**CITY OF RAMSEY LAND USE APPLICATION  
TECHNICAL REVIEW FILE**

<b>DATE</b>	4/3/15	<b>PROJECT ADDRESS</b>	TBD
<b>PROJECT. TITLE</b>	SUNWOOD VILLAGE (SKETCH PLAN, FINAL PLAT, AND SITE PLAN)		
<b>ESCROW #</b>	114596		
<b>DEPARTMENT:</b>	Community Development: Planning Division (Comprehensive Plan and Zoning Code)		
<b>TECHNICAL REVIEWER:</b>	Name: Chris Anderson, City Planner Phone: 763-433-9817 Email: <a href="mailto:canderson@cityoframsey.com">canderson@cityoframsey.com</a>

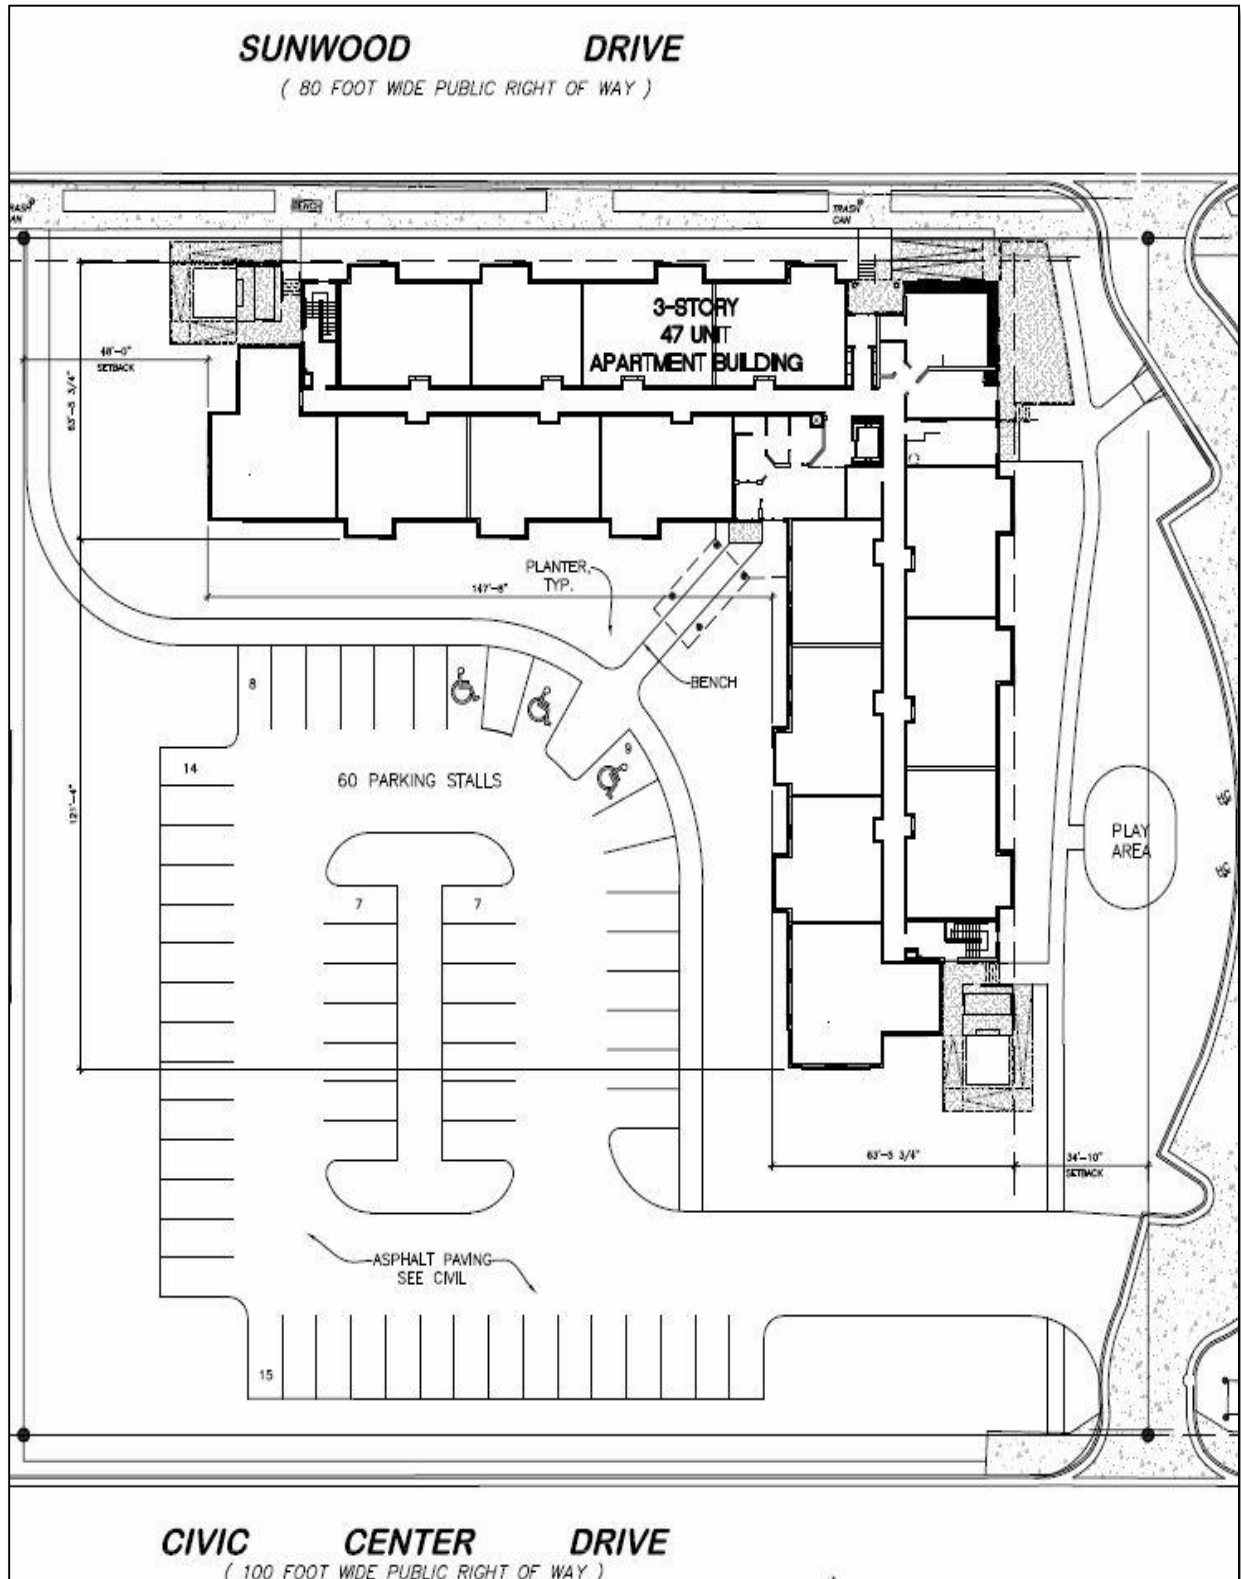
**Sketch Plan and Final Plat:** The project proposes to replat Outlot A, COR ONE into Lot 1 Block 1 SUNWOOD VILLAGE (the “Plat”). The Plat does not propose altering or realigning any property boundaries. The Plat meets or exceeds all applicable dimensional bulk standards. *The Plat should be revised to correctly indicate Veterans Drive rather than Civic Center Drive. The Plat, once approved by City Council, should be recorded after successfully closing on the property.*
